## Memorandum

Re: **Ecology Comments on Pre-Remedial Design Investigation Work Plan, Marine Areas of Jeld Wen Site dated January 24, 2024**

- Site Name: Jeld Wen
- Site Address: 300 W Marine View Dr, Everett, WA 98201-1030
- Facility/Site No.: 2757
- Cleanup Site No.: 4402
- Agreed Order No.: DE 5095

**Figure 9b**  
 Southern Shoreline Area Dioxin/Furan TEQ Without <1-Foot Refusal Data - Proposed Sample Locations

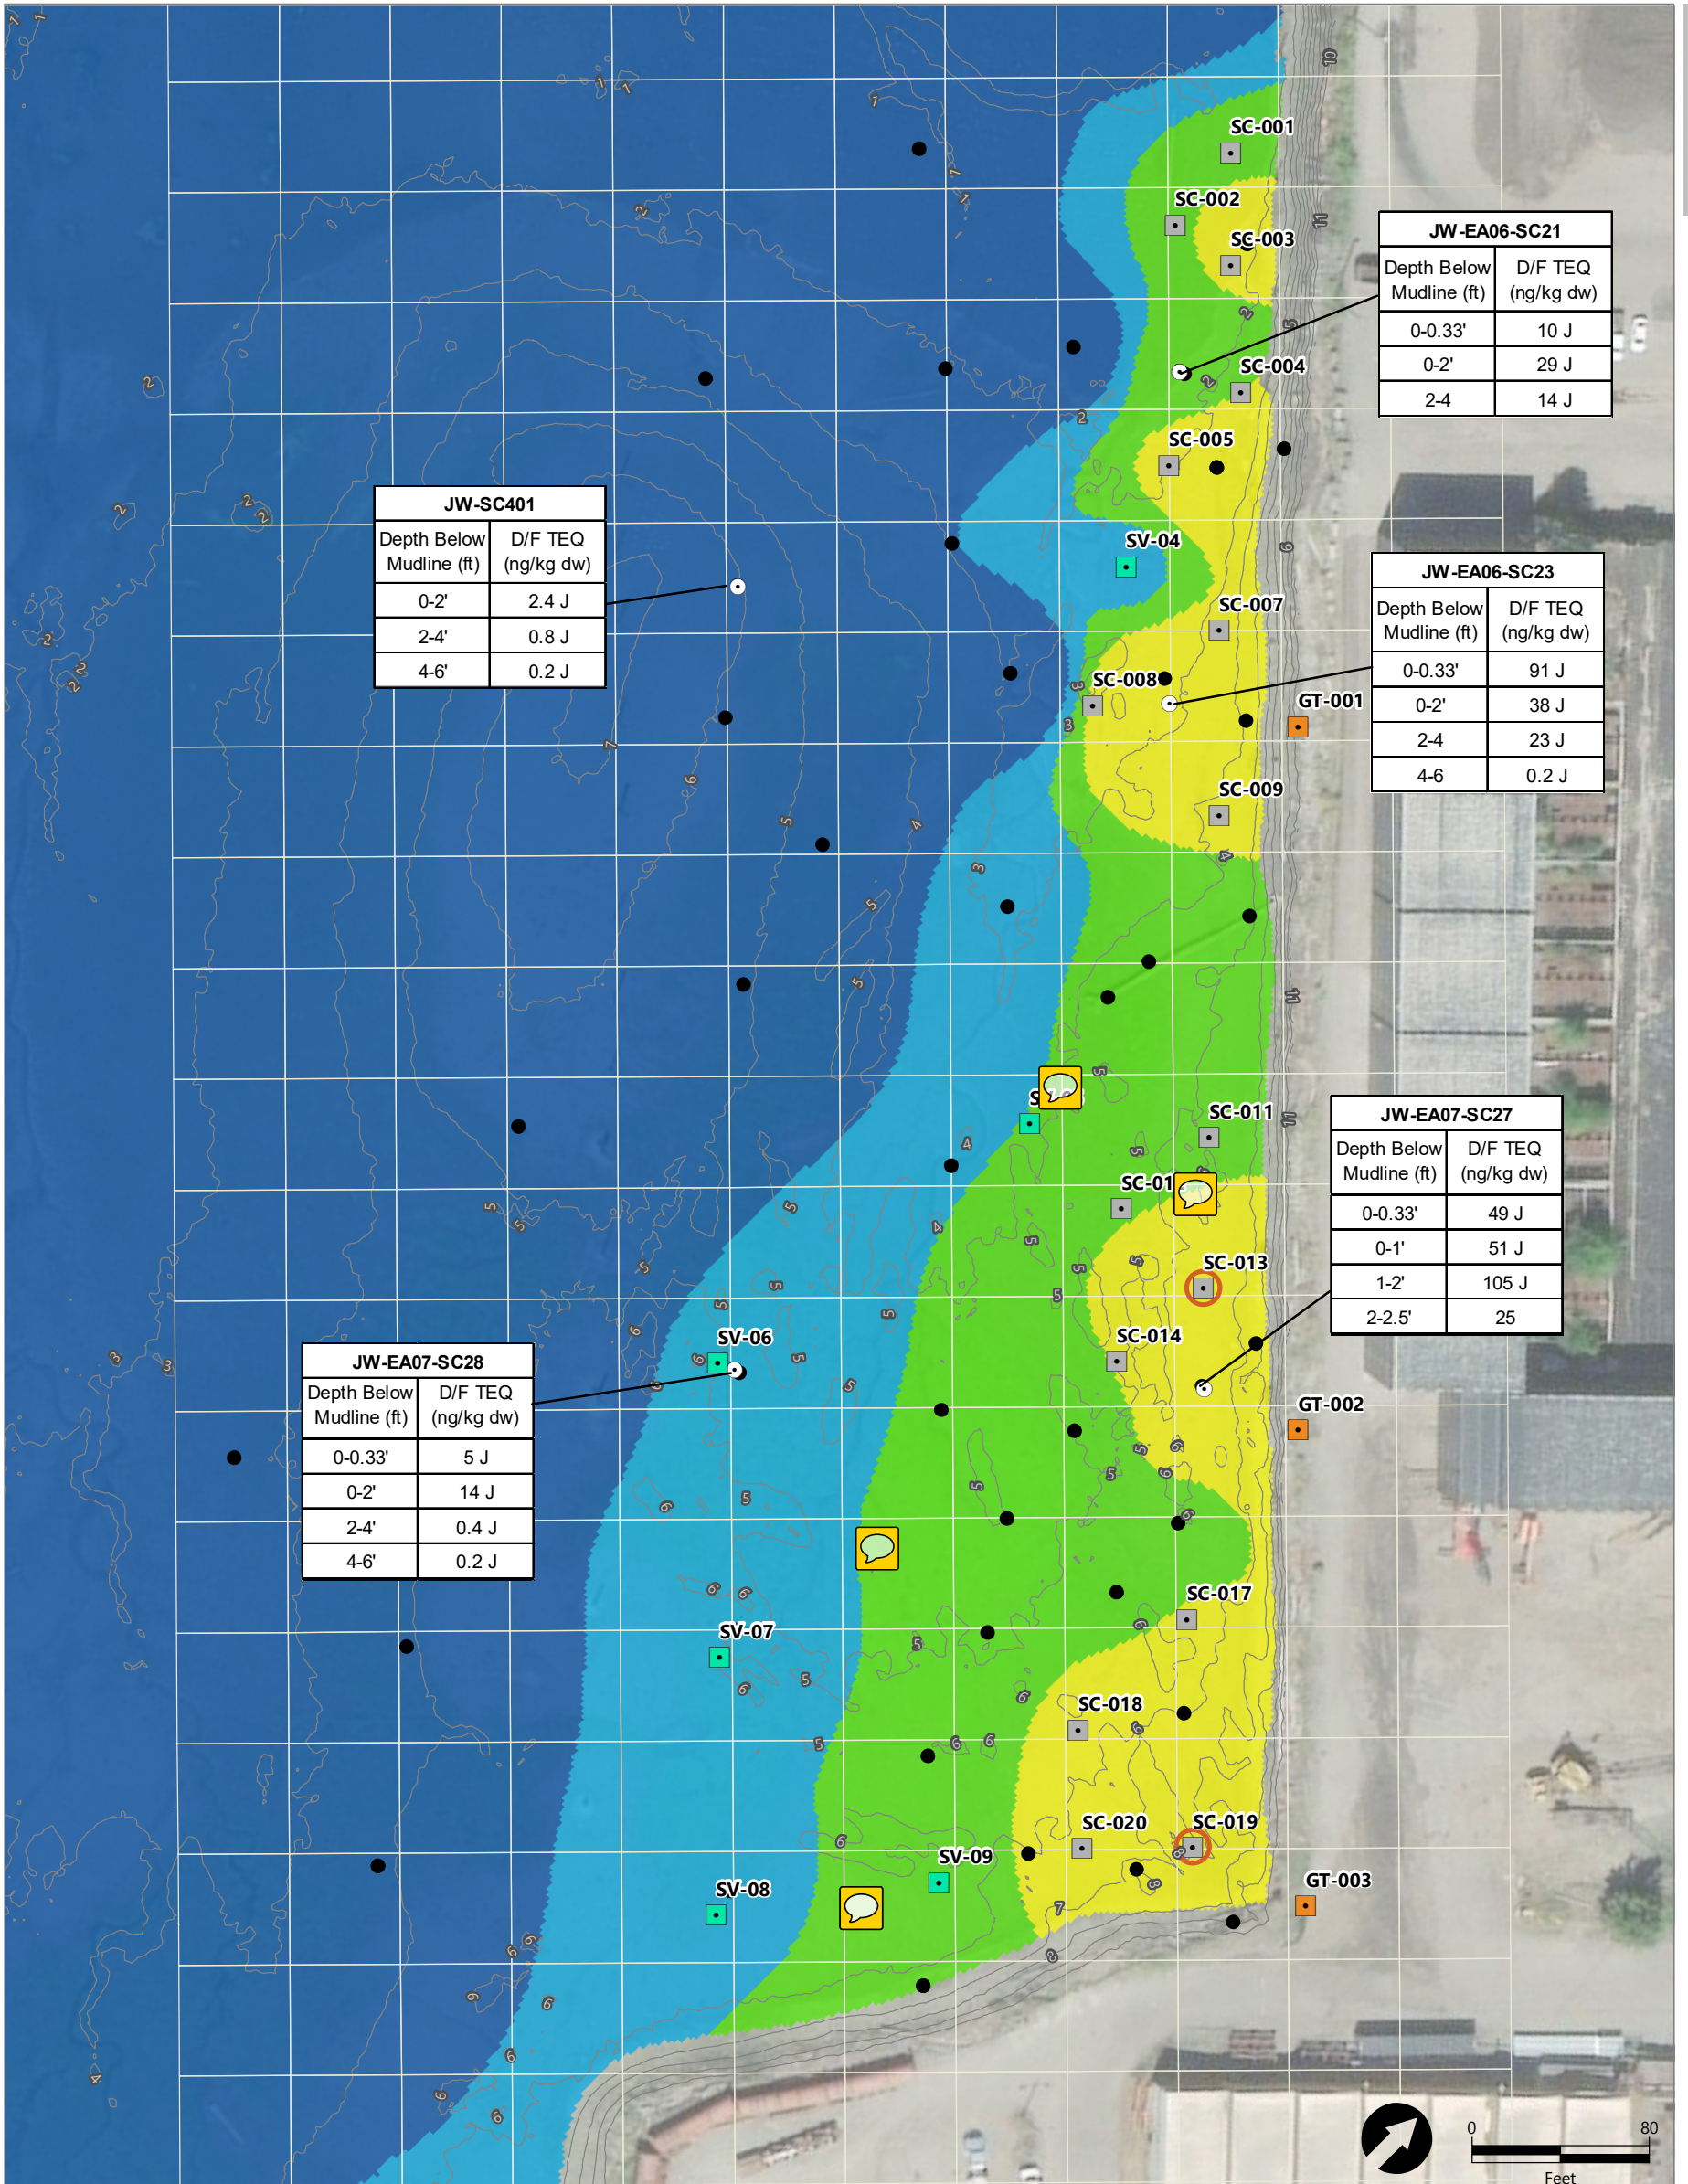
Ecology requests the addition of four sampling locations in the Southern Shoreline area. The additional sampling locations are shown on the below map, and additional information is provided within PDF comments. These four sampling locations are intended to provide for a higher confidence in the delineation of the SMAs within the Southern Shoreline Area.
